**Subject: Palo Verde Nuclear Generating Station (PVNGS)
Units 1, 2, and 3
Docket Nos. STN 50-528/529/530
Core Operating Limits Reports: Unit 1 - Revision 6;
Unit 2 - Revision 5; and Unit 3 - Revision 8**

Pursuant to PVNGS Technical Specification 5.6.5.d, enclosed are the following revised Core Operating Limits Reports (COLRs) for PVNGS:

These COLR revisions were implemented on March 15, 2002. The changes implemented by these COLR revisions consist of adding clarifying information to section 3.1.7 to define conditions under which the CEA overlap may be modified from the nominal values specified in Figures 3.1.7-1 and 3.1.7-2.

**Core Operating Limits Reports for
Palo Verde Nuclear Generating Station**

FIGURE 3.1.7-1

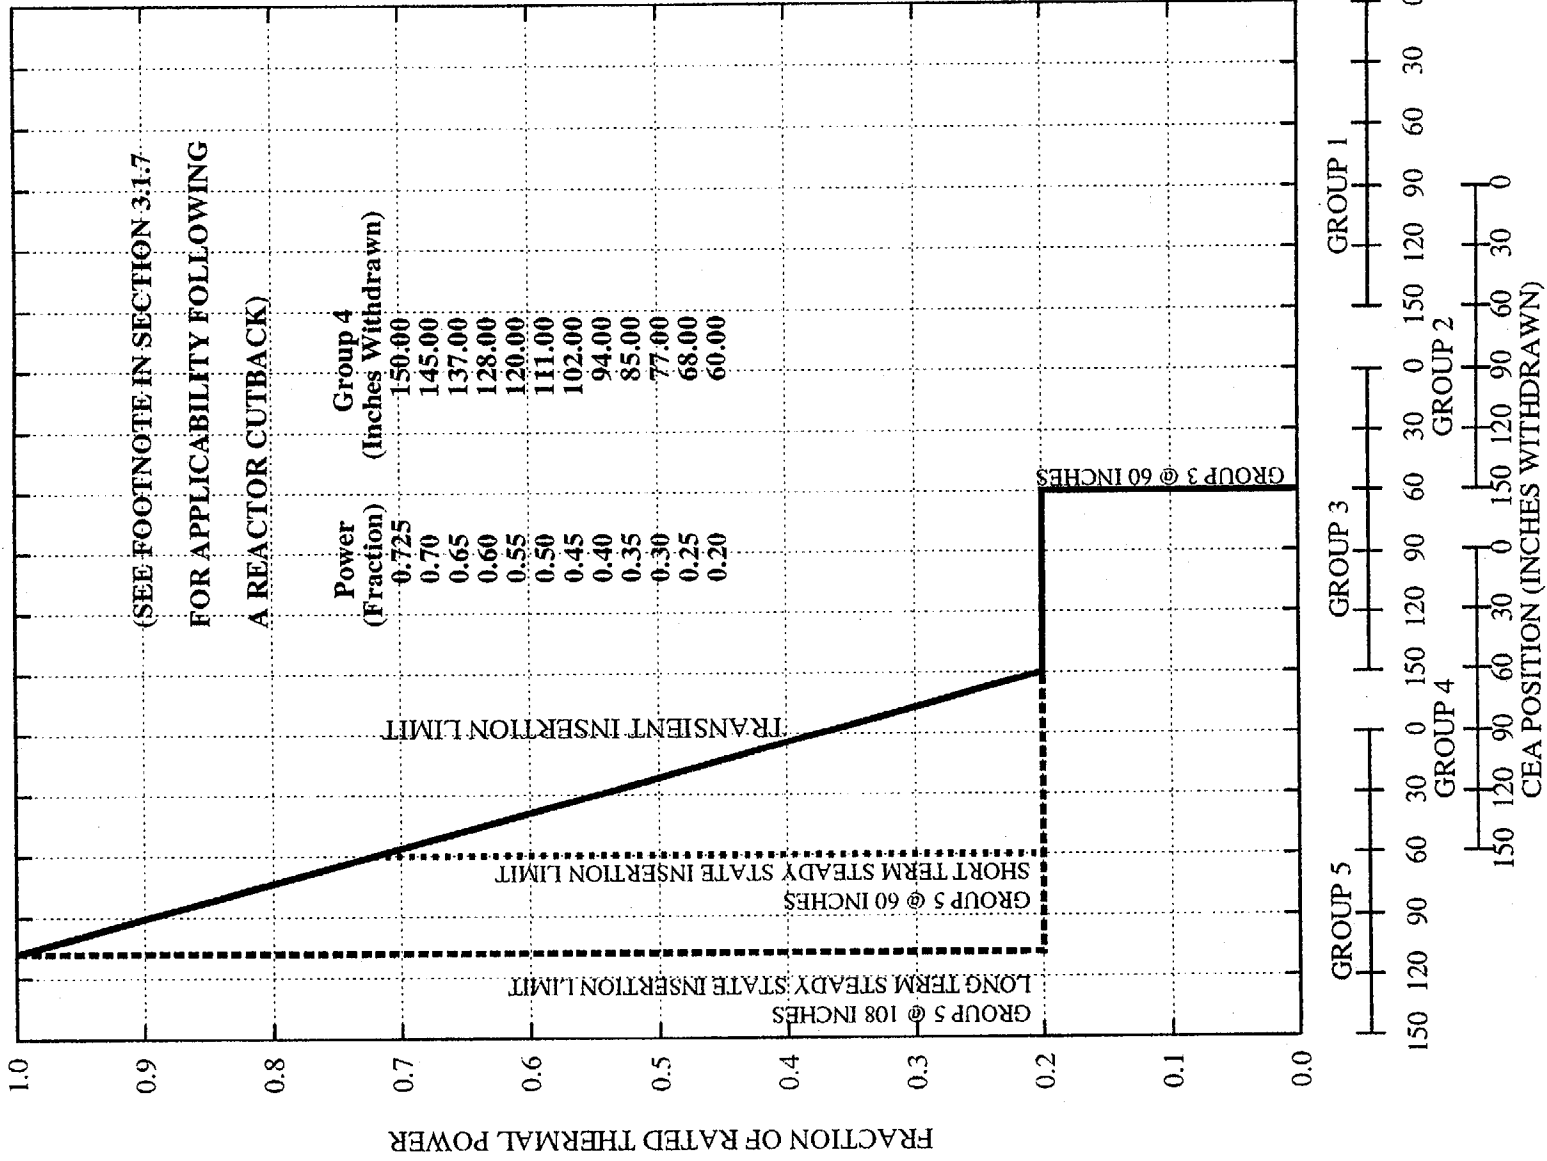
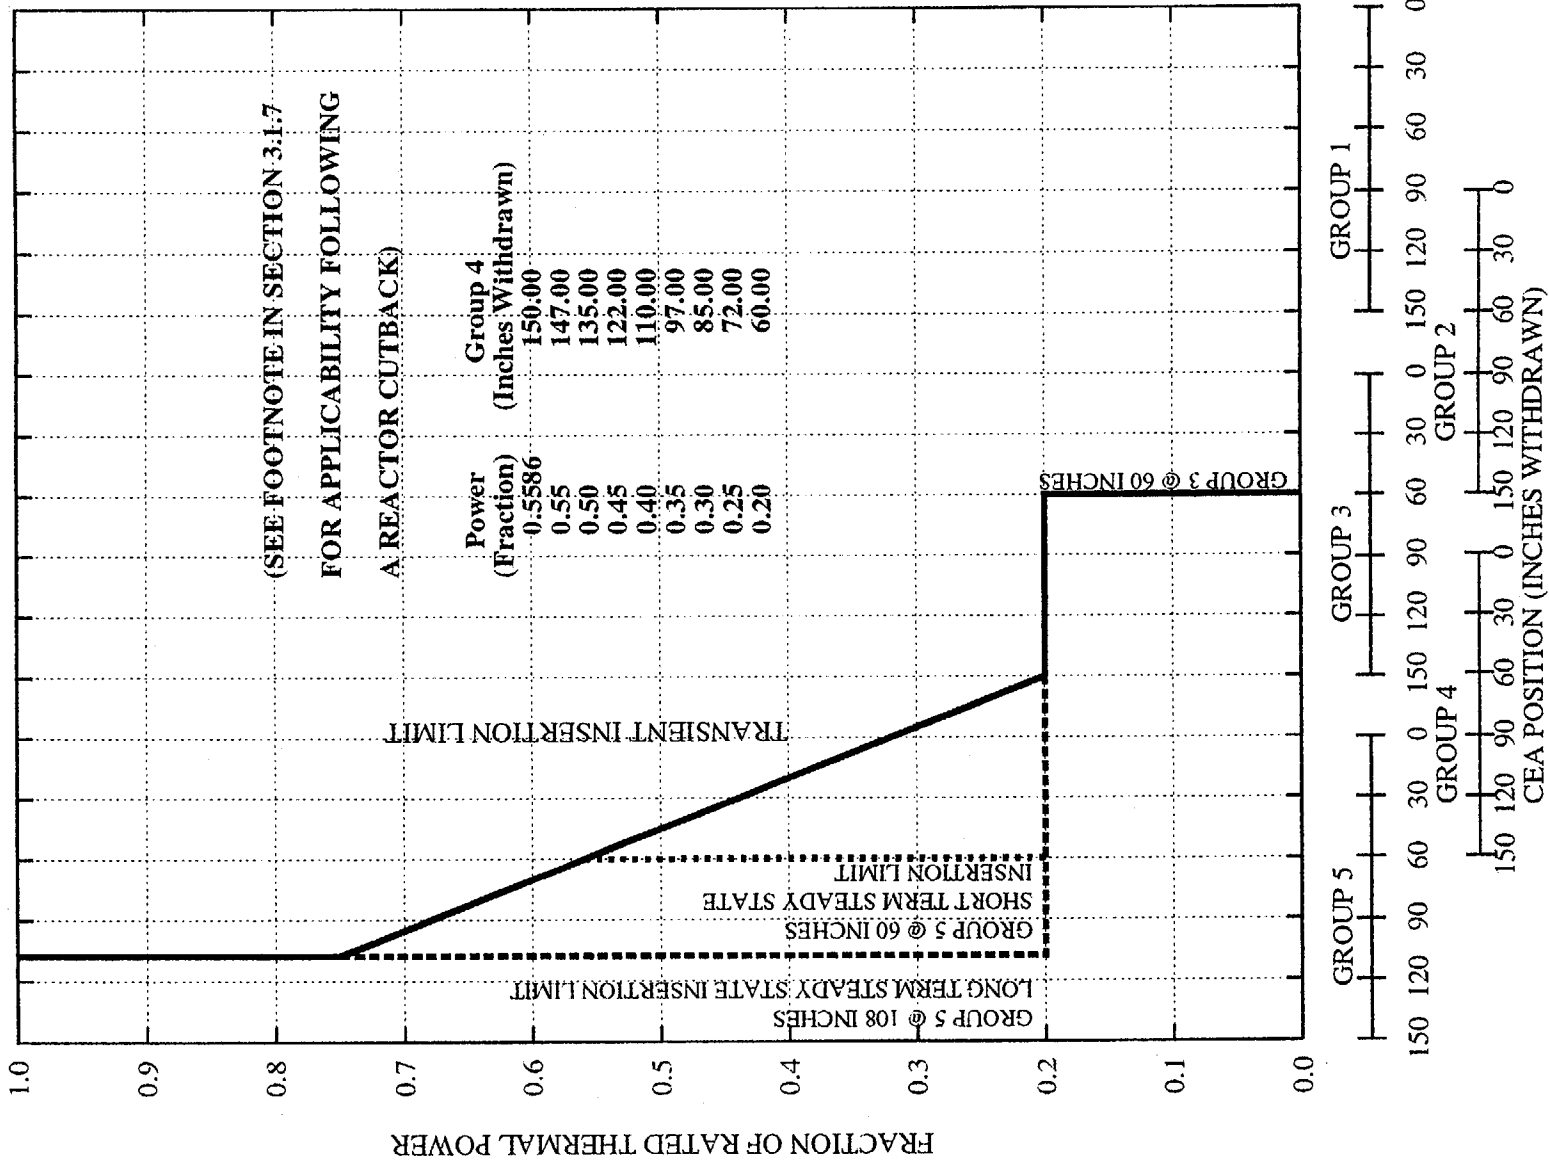
²The separation between Regulating Groups 4 and 5 may be reduced from the 90 inch value specified in Figures 3.1.7-1 and 3.1.7-2 provided that each of the following conditions are satisfied:

- a) Regulating Group 4 position is between 60 and 150 inches withdrawn.
- b) Regulating Group 5 position is maintained at least 10 inches lower than Regulating Group 4 position.
- c) Both Regulating Group 4 and Regulating Group 5 positions are maintained above the Transient Insertion Limit specified in Figure 3.1.7-1 (COLSS In Service) or Figure 3.1.7-2 (COLSS Out of Service)

FIGURE 3.1.7-1

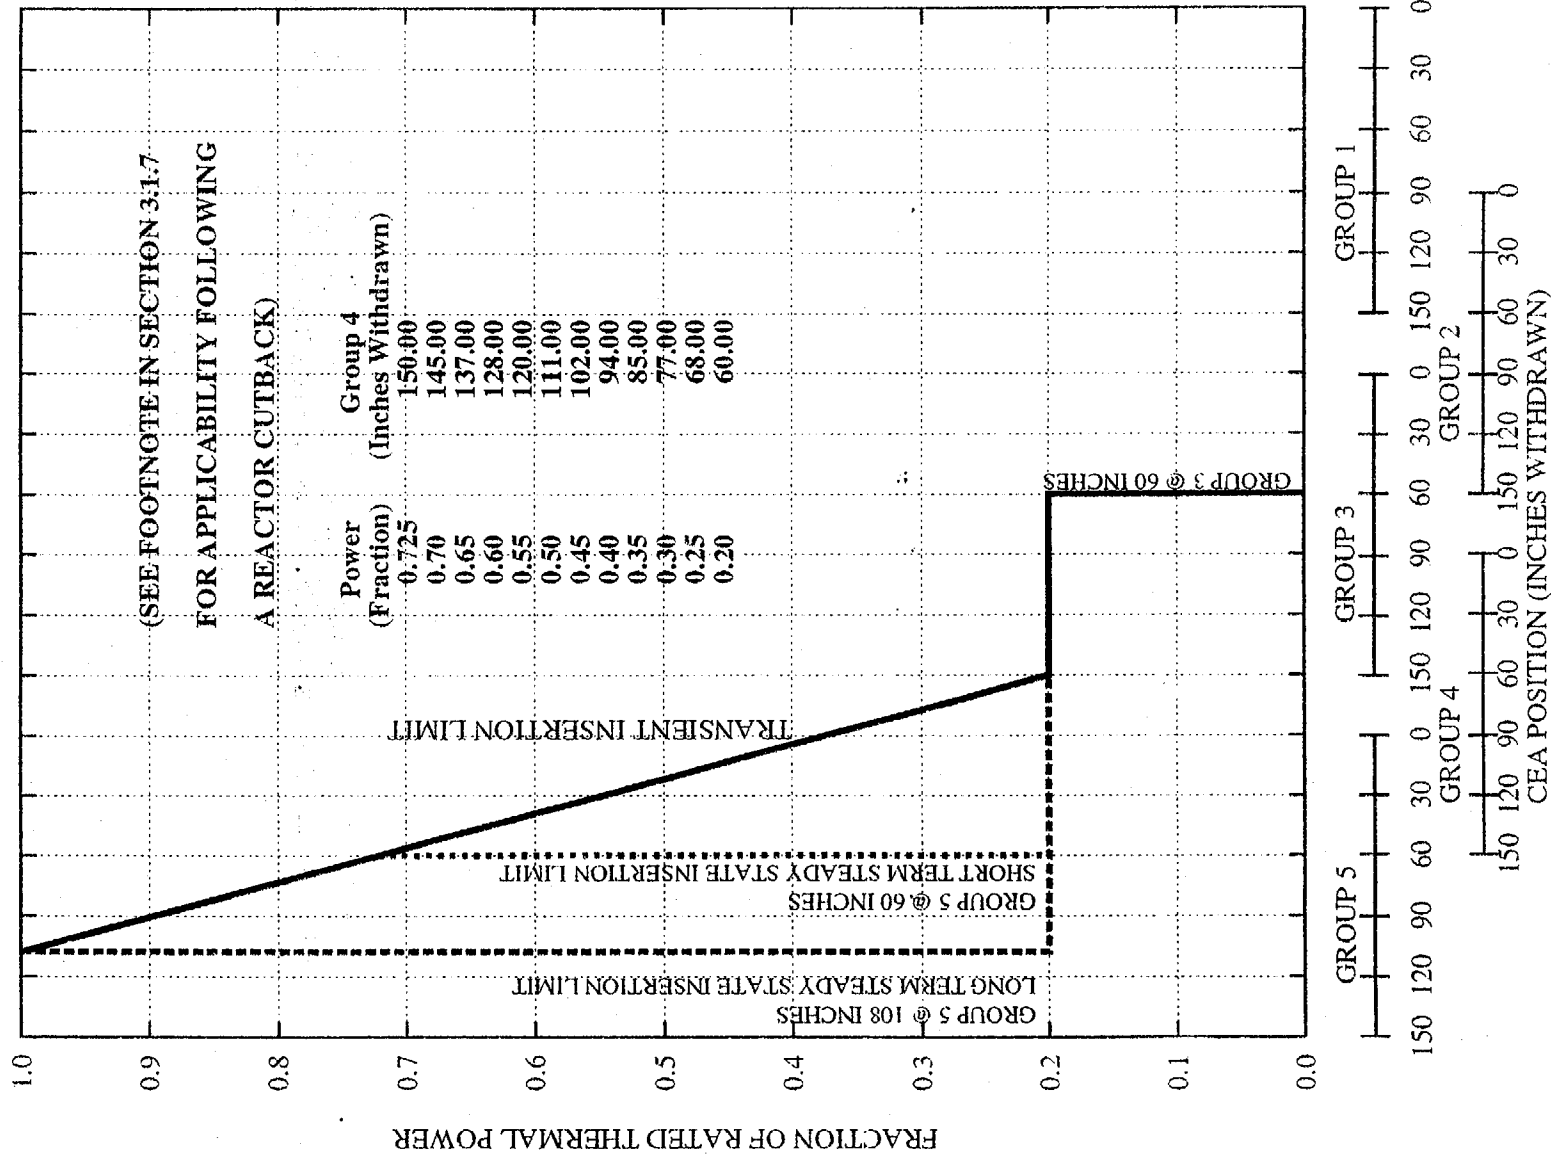
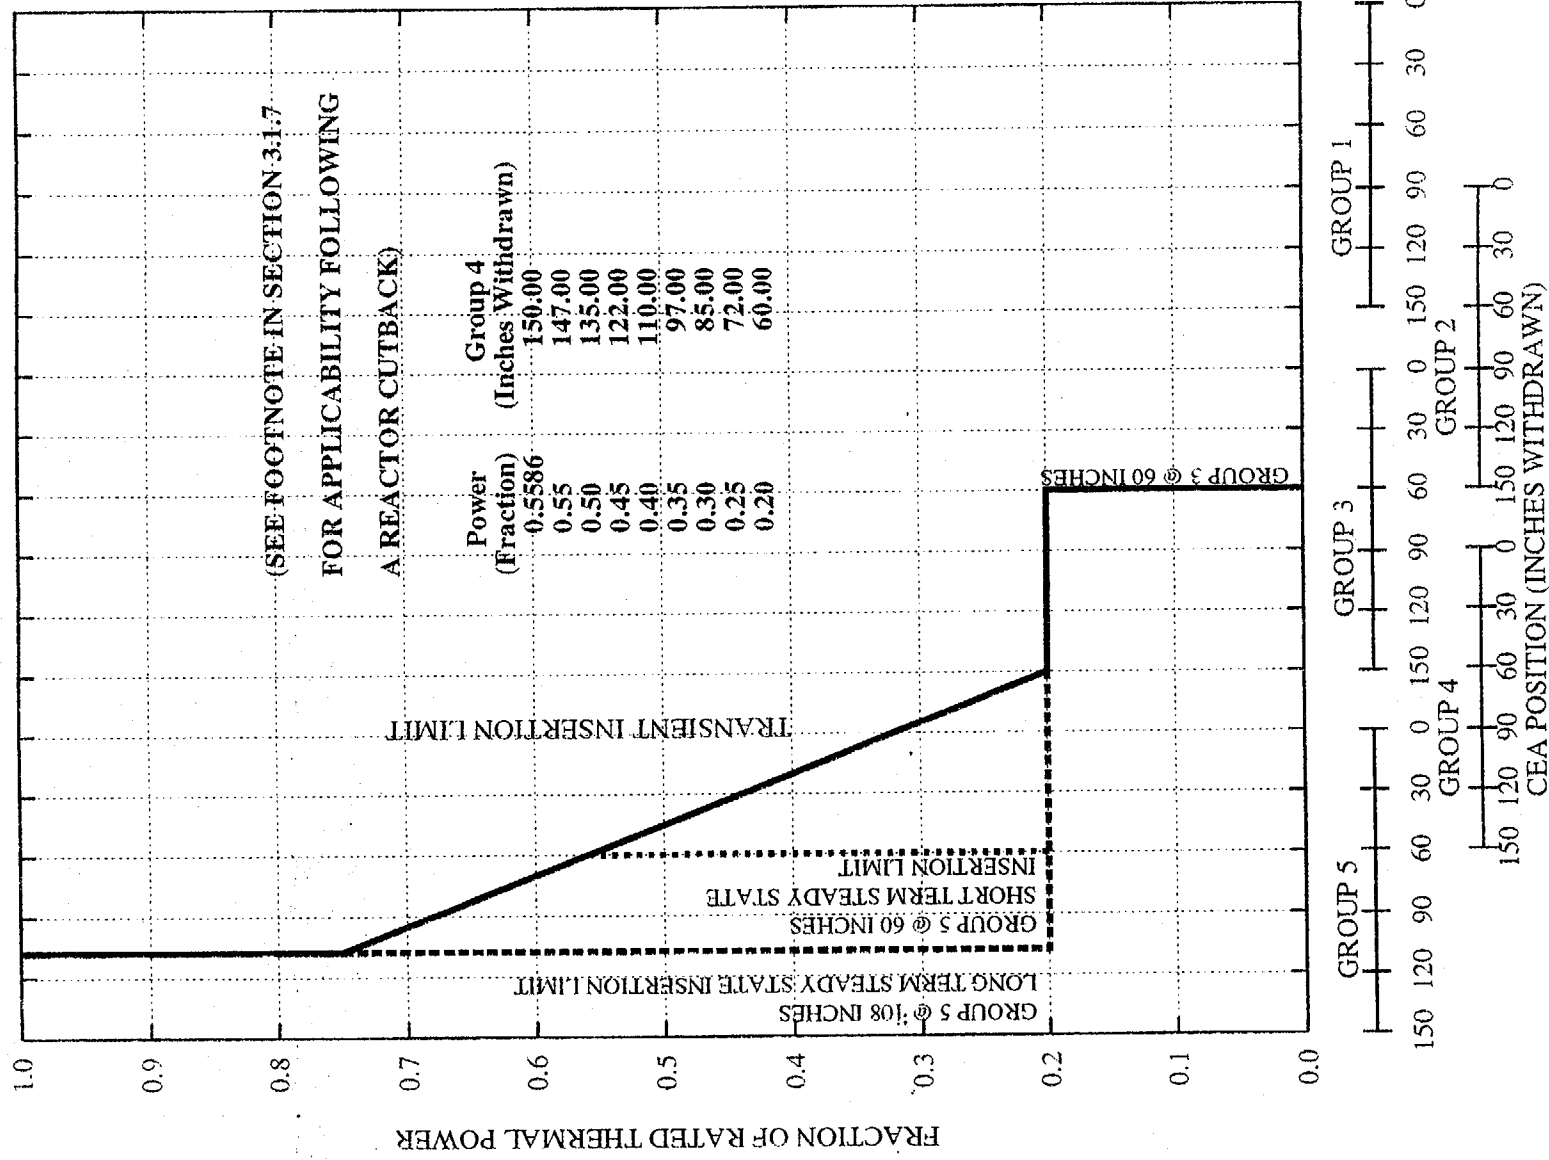
² The separation between Regulating Groups 4 and 5 may be reduced from the 90 inch value specified in Figures 3.1.7-1 and 3.1.7-2 provided that each of the following conditions are satisfied:

- a) Regulating Group 4 position is between 60 and 150 inches withdrawn.
- b) Regulating Group 5 position is maintained at least 10 inches lower than Regulating Group 4 position.
- c) Both Regulating Group 4 and Regulating Group 5 positions are maintained above the Transient Insertion Limit specified in Figure 3.1.7-1 (COLSS In Service) or Figure 3.1.7-2 (COLSS Out of Service)

FIGURE 3.1.7-1

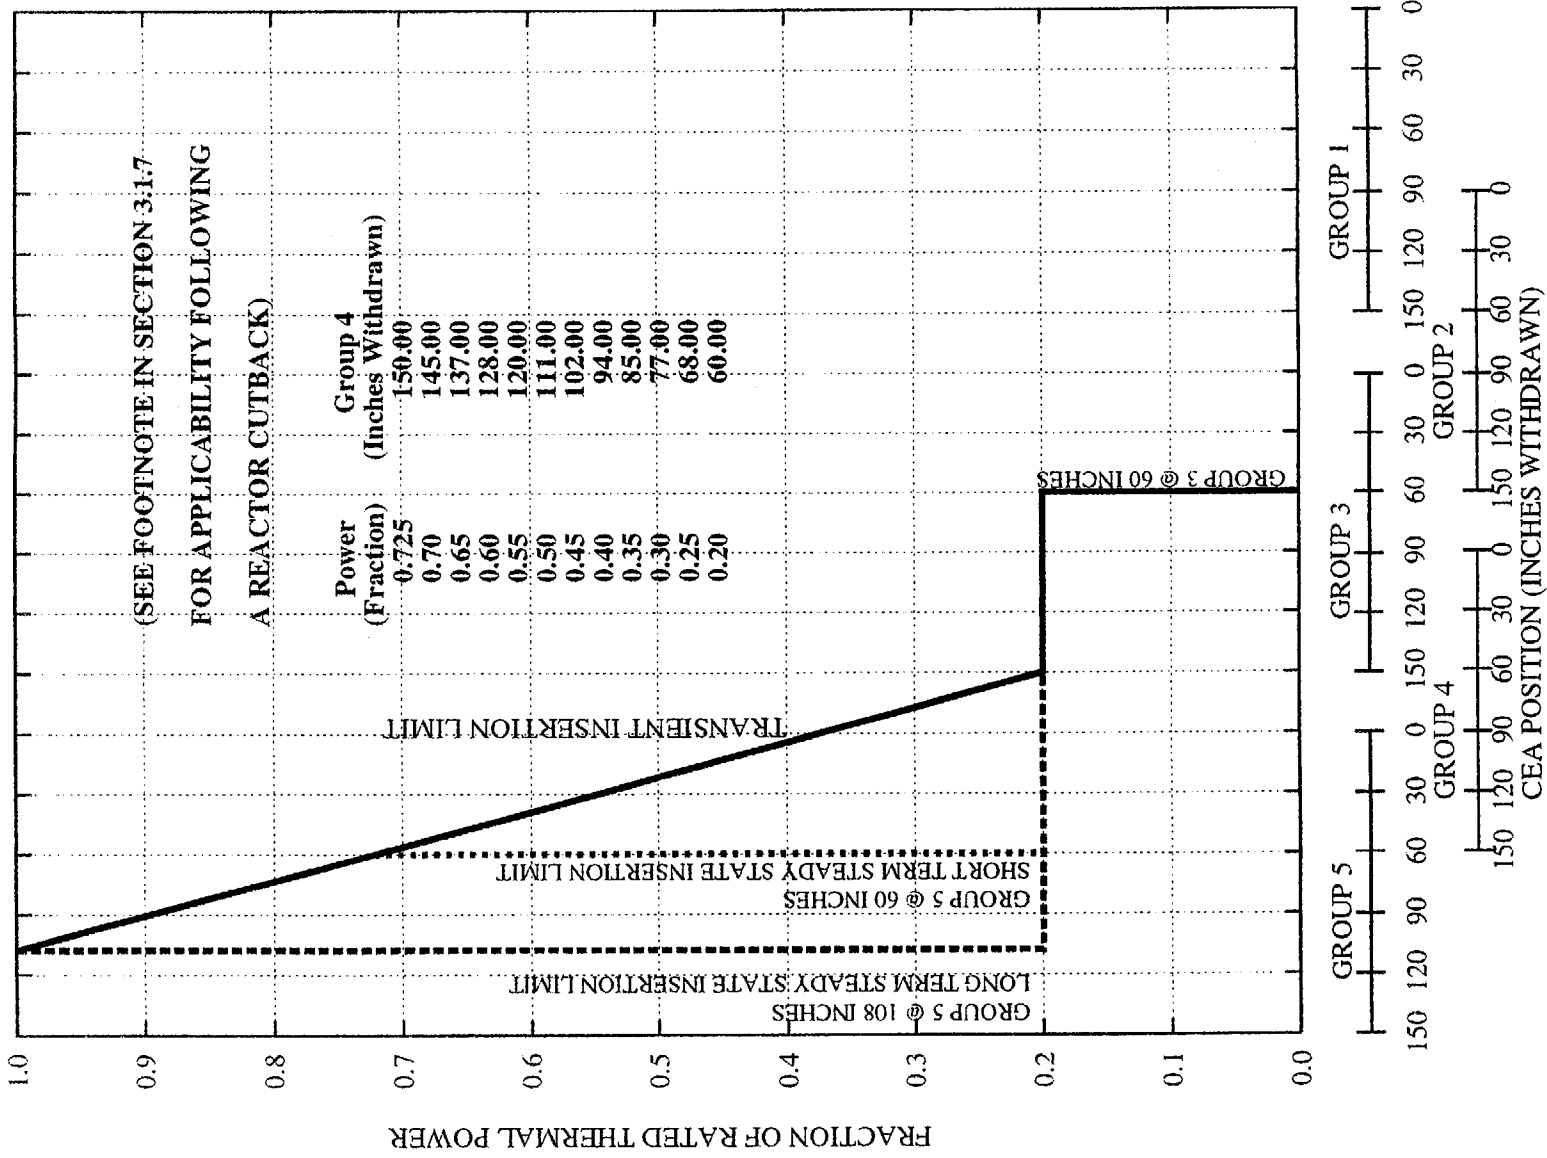
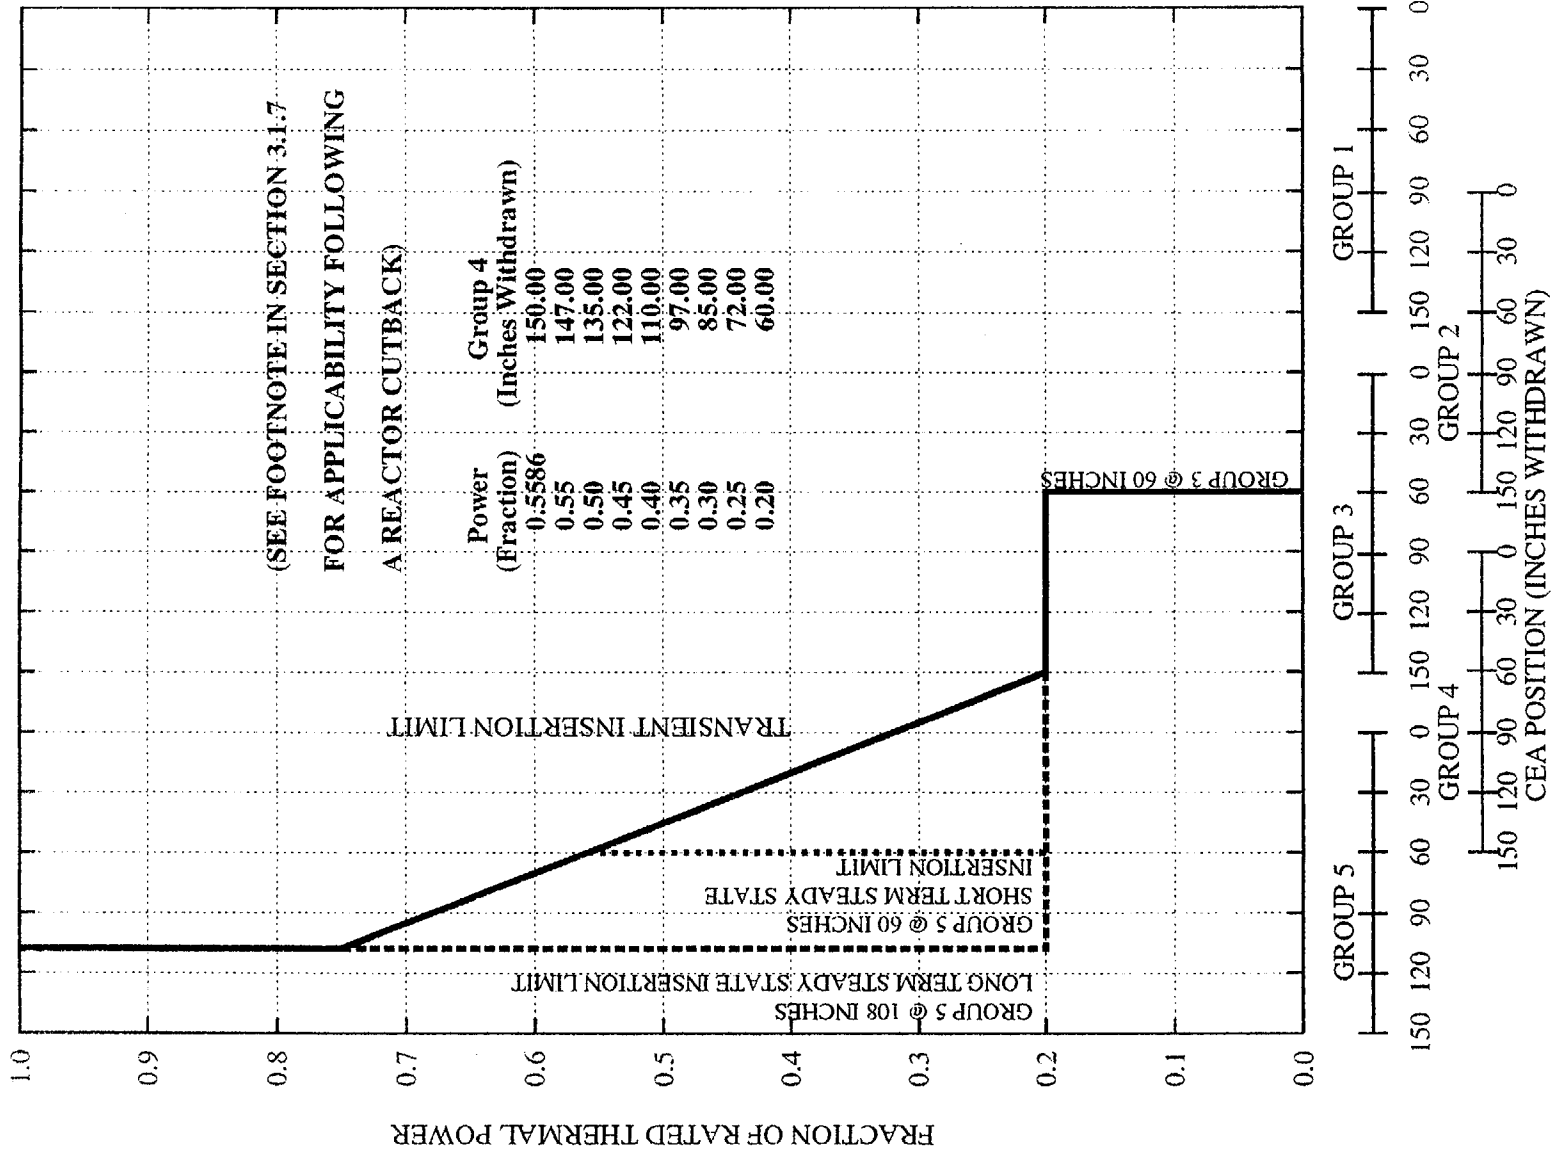
²The separation between Regulating Groups 4 and 5 may be reduced from the 90 inch value specified in Figures 3.1.7-1 and 3.1.7-2 provided that each of the following conditions are satisfied:

- a) Regulating Group 4 position is between 60 and 150 inches withdrawn.
- b) Regulating Group 5 position is maintained at least 10 inches lower than Regulating Group 4 position.
- c) Both Regulating Group 4 and Regulating Group 5 positions are maintained above the Transient Insertion Limit specified in Figure 3.1.7-1 (COLSS In Service) or Figure 3.1.7-2 (COLSS Out of Service)
